# **Draft Safety Evaluation Report**

For the proposed reclamation plan  
for the Sequoyah Fuels Corporation  
Site in Gore, Oklahoma; Materials  
License No. SUB-1010

Docket No. 40-8027  
Sequoyah Fuels Corporation

**U.S. Nuclear Regulatory Commission**

**Figure 5-1 - Liner Cover Material Grain Size Curve**

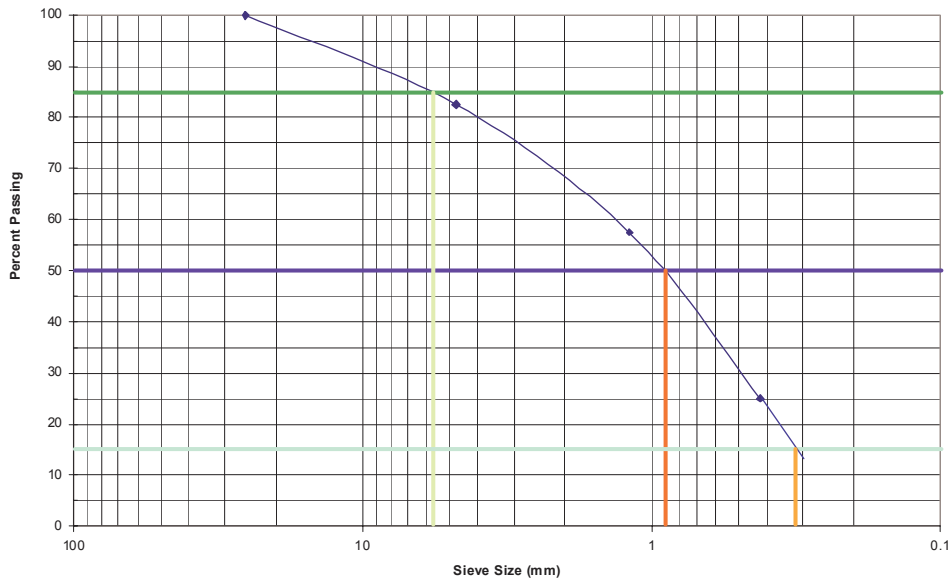
To determine the adequacy of the liner cover material filtering capacity, NRC computed a grain size distribution curve using the averages for the No. 4, 16, and 40 sieves (Figure 5-1). Linear extrapolation was used to continue the curve to the lower percent passing values. Quantiles of interest for the liner cover material are  $D_{50}$  and  $D_{15}$ , which equal 0.9 mm and 0.32 mm, respectively. Because no grain size data were provided for the fine-grained soil, conservative values for the  $D_{85}$  (0.074 mm) and  $D_{50}$  (0.01 mm), were assumed. Quantiles for the liner cover and the overlying fine-grained soil were compared using the USACE filter equations:

Solutions to equations 1 and 2 are 32 and 21, respectively. This indicates that the liner cover is not designed to prevent piping; however, it will provide sufficient drainage according to equation 2. The fact that the liner cover material does not meet the piping criteria may indicate that this layer is susceptible to clogging by fines from the overlying soil as they migrate through the liner cover material. **The NRC staff, therefore, considers this issue open. A similar issue was raised in the Section 2.3.2 of this SER regarding the geotechnical stability of the disposal cell.**

29. The licensee needs to provide information to show that the liner cover material will comply with standard filter design criteria to prevent piping and promote drainage.	5.3.2
